Product/Process
Change
Notification
PCN08044

| Product: | PCle | | Part Numbers Concerned: | See attached list |

Product Design Change

Removing the metal clip from the post

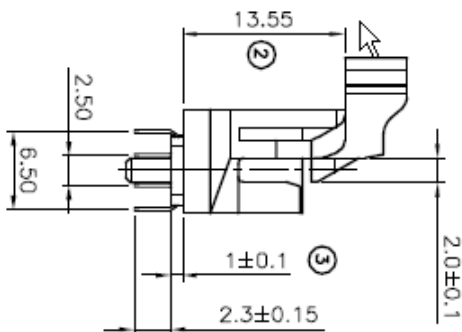
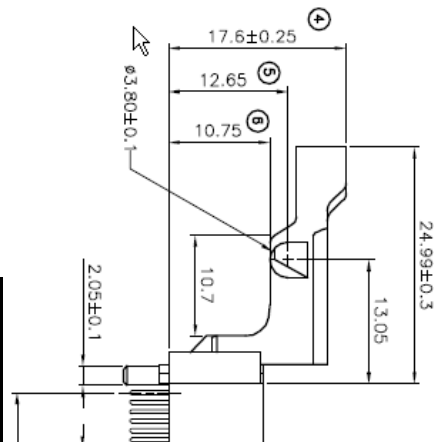
W/ CLIP
CHANGE BEFORE

WO/ CLIP
CHANGE AFTER

Dimension and Apparel changes

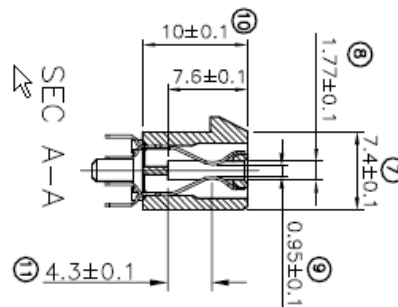
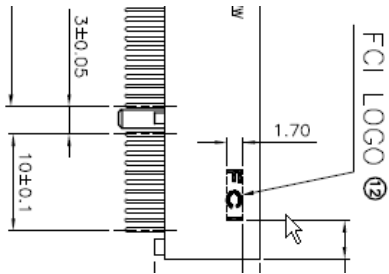
| Location# | Before | After |
| 1 | 1.7 \pm 0.1 | 1.78 \pm 0.1 |
| 2 | 13.75 | 13.55 |
| 3 | 0.8 \pm 0.1 | 1.0 \pm 0.1 |

| 4 | 17.8 \pm 0.25 | 17.6 \pm 0.25 |
| 5 | 12.85 | 12.65 |
| 6 | 10.95 | 10.75 |

| 7 | 7.2 \pm 0.1 | 7.4 \pm 0.1 |
| 8 | 1.85 \pm 0.1 | 1.77 \pm 0.1 |
| 9 | 0.8 \pm 0.1 | 0.95 \pm 0.1 |
| 10 | 10.2 \pm 0.1 | 10.0 \pm 0.1 |
| 11 | 4.4 \pm 0.1 | 4.3 \pm 0.1 |
| 12 | Areva | FCI |
